**CALIFORNIA COASTAL COMMISSION**

## STAFF REPORT: MATERIAL AMENDMENT

**Amendment Application No.:** 1-18-1078-A1

**Proposed Amendment:** (1) Modify special conditions imposing hydro-acoustic limitations on pile-driving for the replacement of the southbound 101 Jacoby Creek Bridge; and (2) add an auxiliary lane on northbound 101 between the Bracut Maintenance Station and Bayside Road.

Figure 1: Estimate of Number of Pile Strikes Before Stoppage for Cumulative SEL Limits.

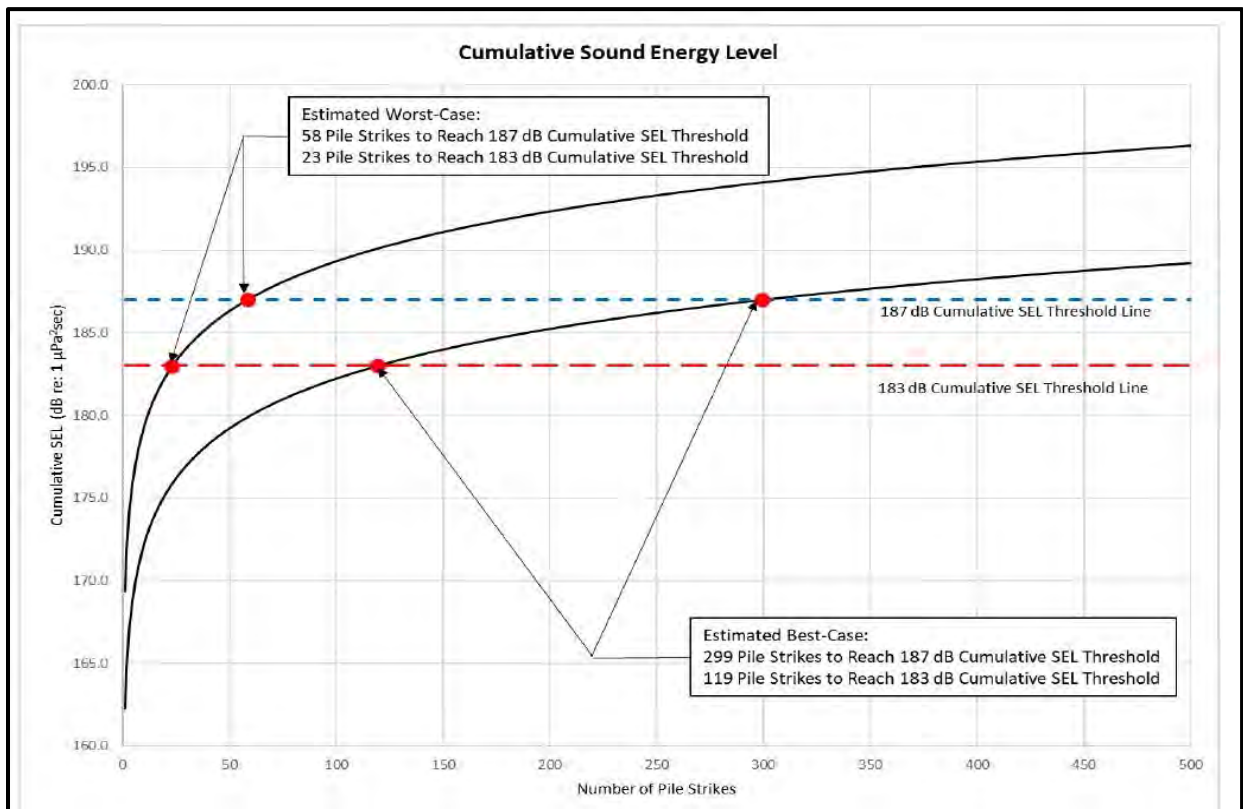
Caltrans estimates that the stricter 183 dB SEL limit would require an extra year of construction for each set of piles, extending the construction period by two years and up to a total of four years. These findings are summarized in Table 2 on page 9 of the Caltrans Hydroacoustic Criteria Memo ([Exhibit 6](#)) and in the chart below in Figure 1, both of which include best-case and worst-case scenarios. Table 2 relates the number of pile strikes under best-case and worst-case scenarios to reach the 183 and 187 cumulative dB SEL thresholds to the estimated number of working days per pile, the number of working days per bridge, and the number of construction seasons for each bridge. The chart demonstrates the logarithmic nature of the hydroacoustic criteria thresholds and that there can be a substantial difference in time before pile driving is stopped under the two criteria.
